# Wollongong Local Planning Panel Assessment Report | 17 December 2020

<b>WLPP No.</b>	Item No. 2
<b>DA No.</b>	DA-2019/1462
<b>Proposal</b>	Demolition of existing structures, retention of heritage hotel and construction of a mixed use (Commercial / Residential) development
<b>Property</b>	98-110 Princes Highway DAPTO Lot 1 DP 745653 and Lot 1 DP 564523
<b>Applicant</b>	ADM Architects
<b>Responsible Team</b>	Development Assessment and Certification - City Wide Team (KR)

## ADDENDUM REPORT

Title  
DEVELOPMENT APPLICATION  
GROUND FLOOR PLAN

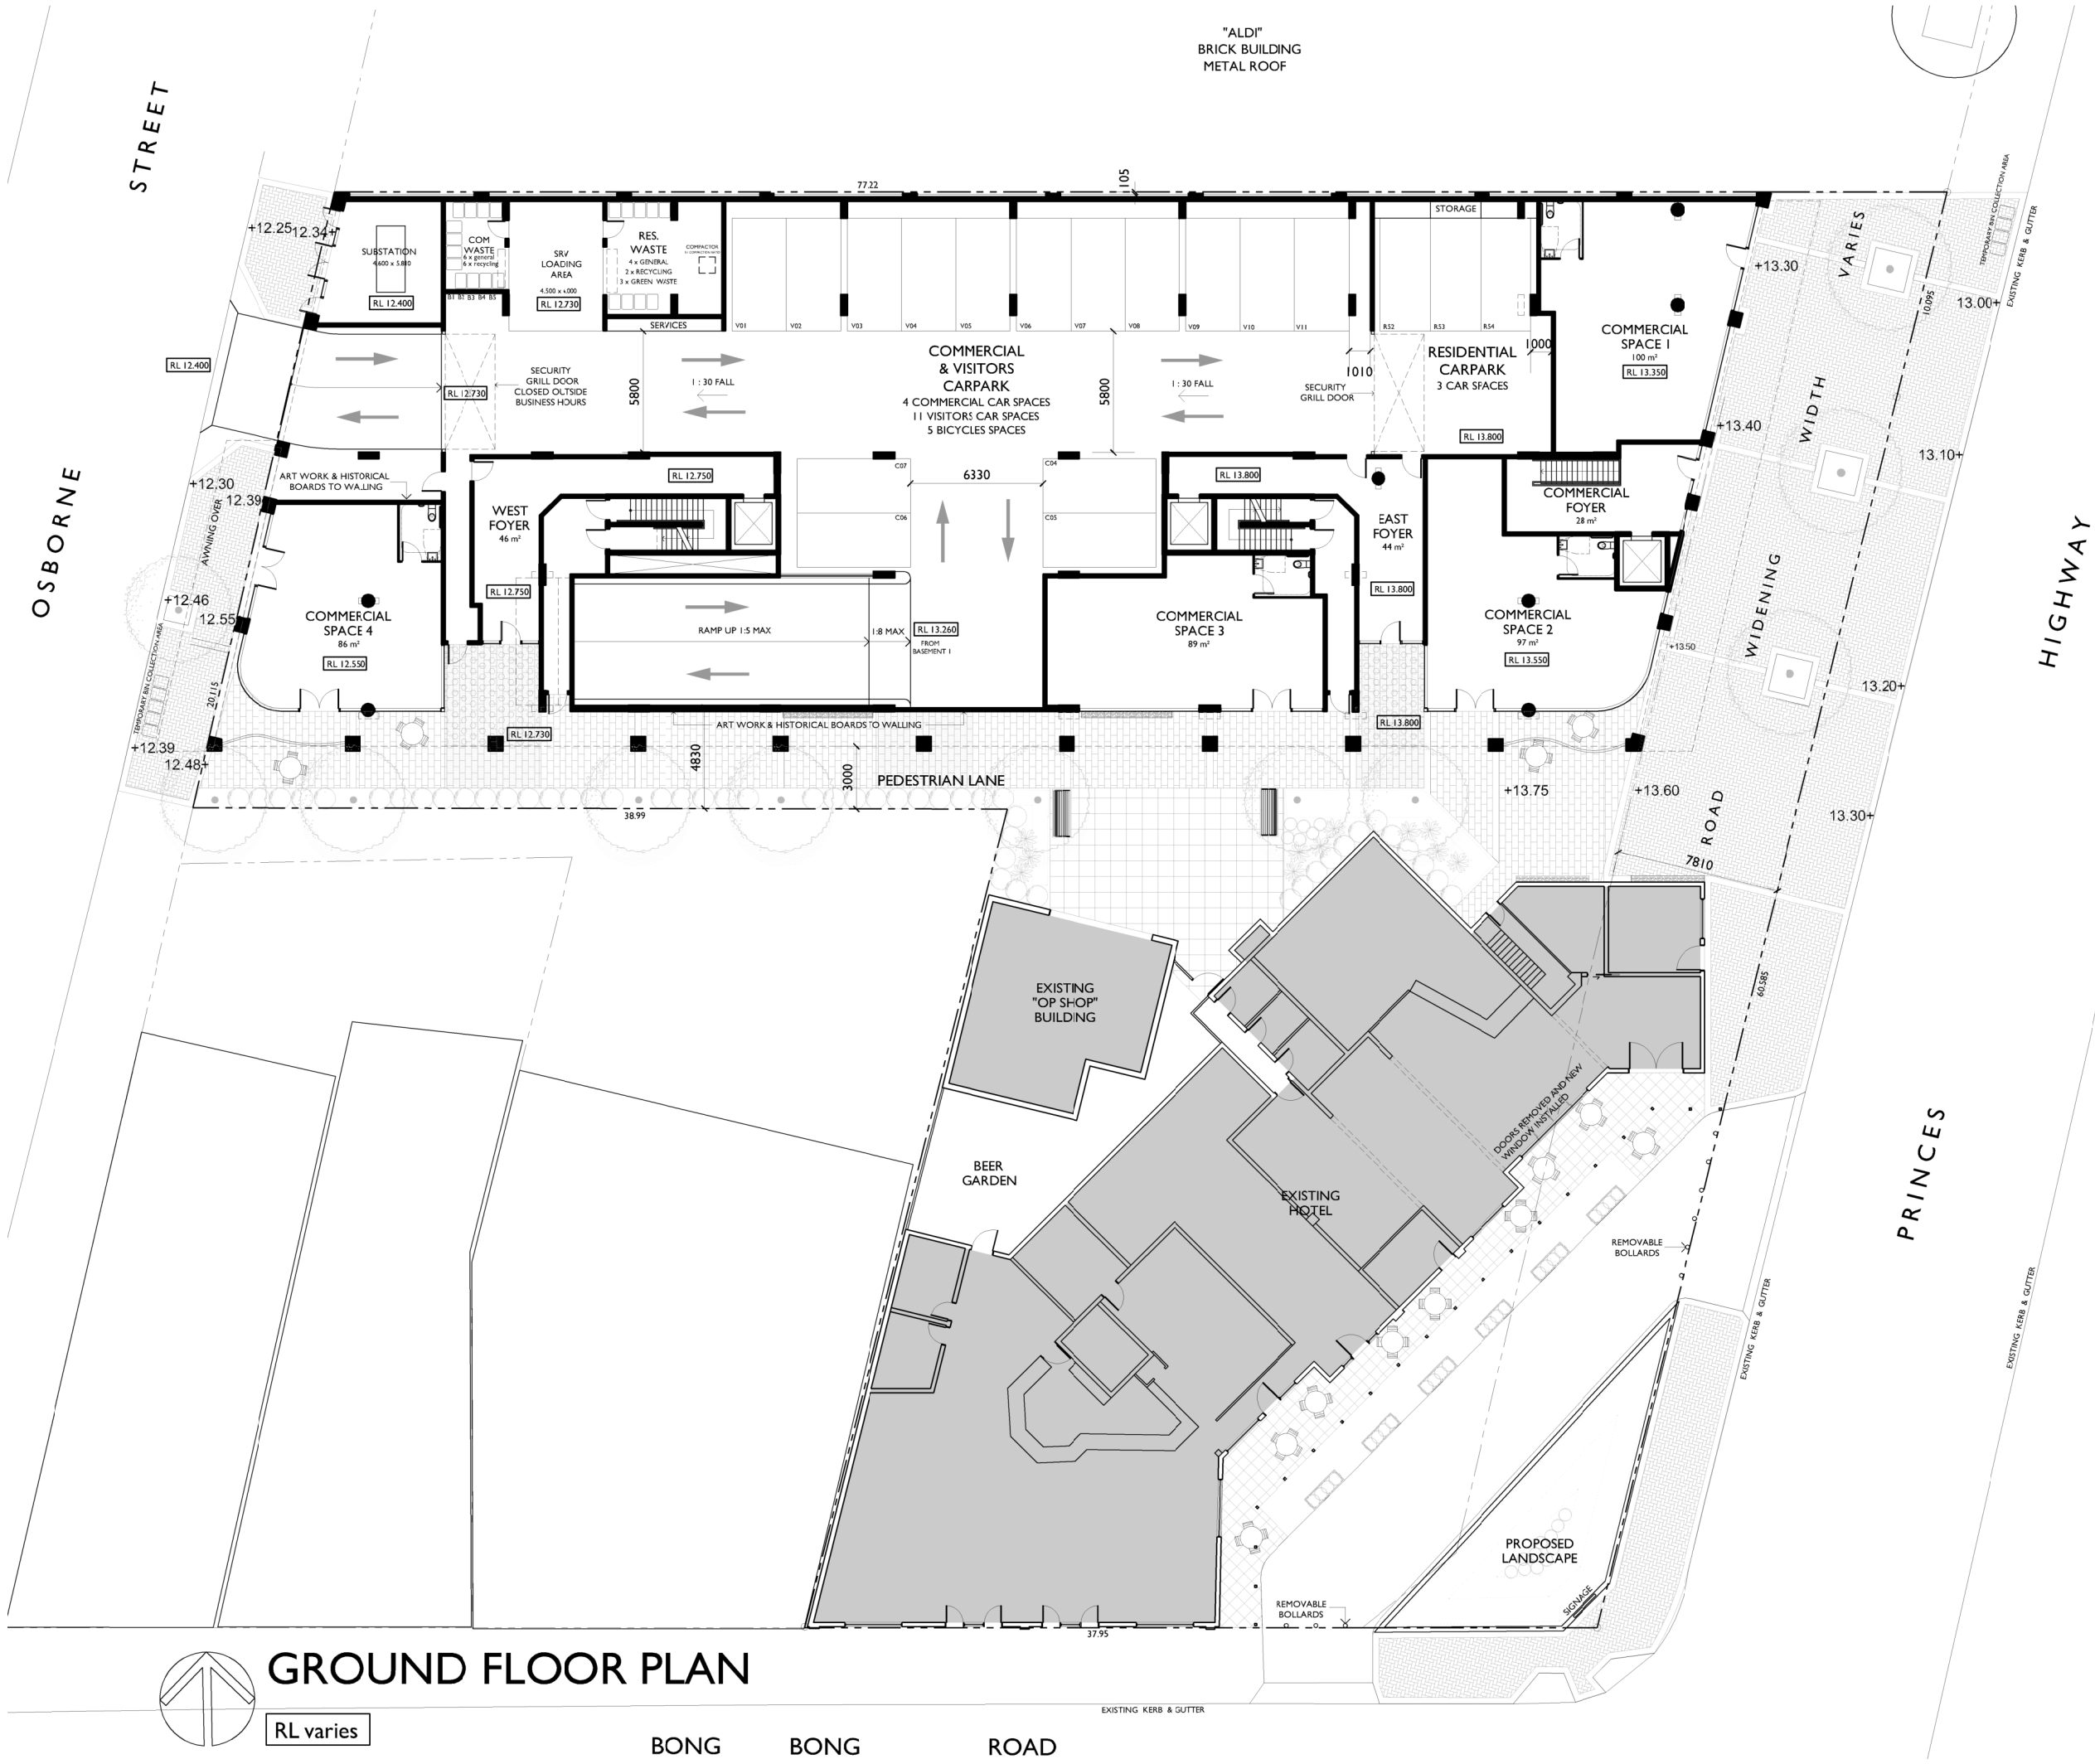
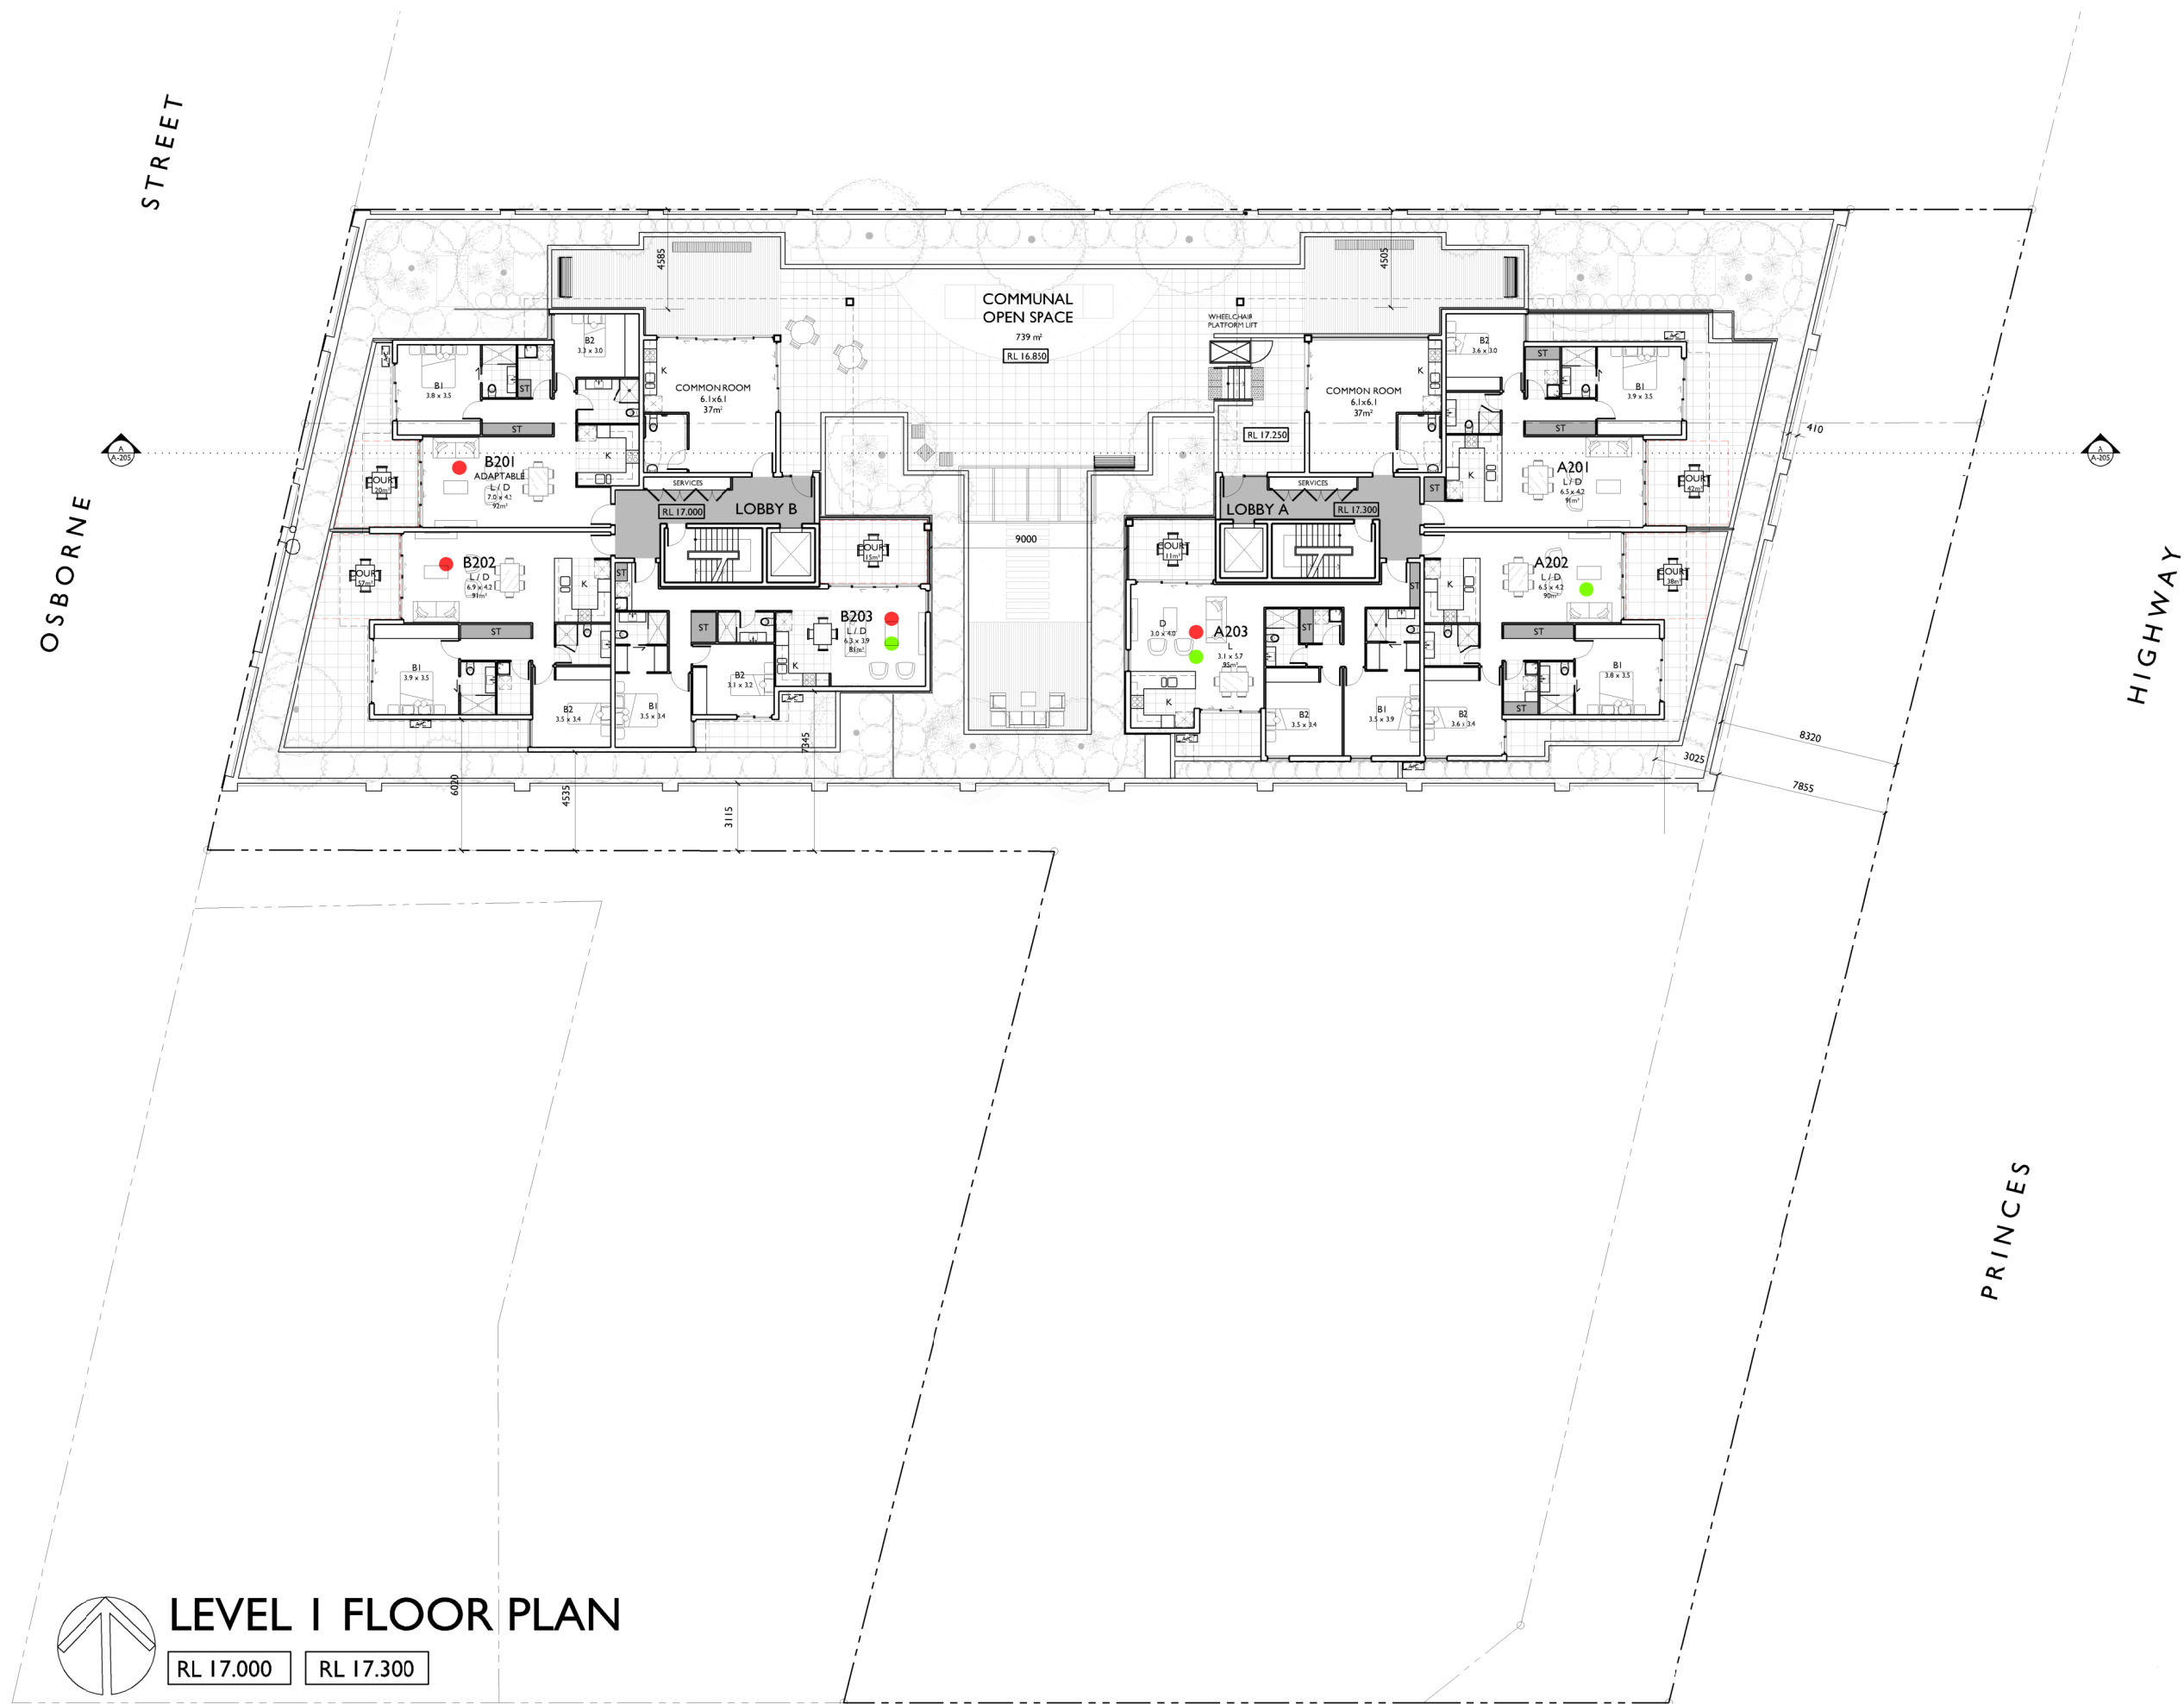
As shown on the amended Ground Floor Plan the compactus significantly reduced the waste servicing requirements for residential as follows:
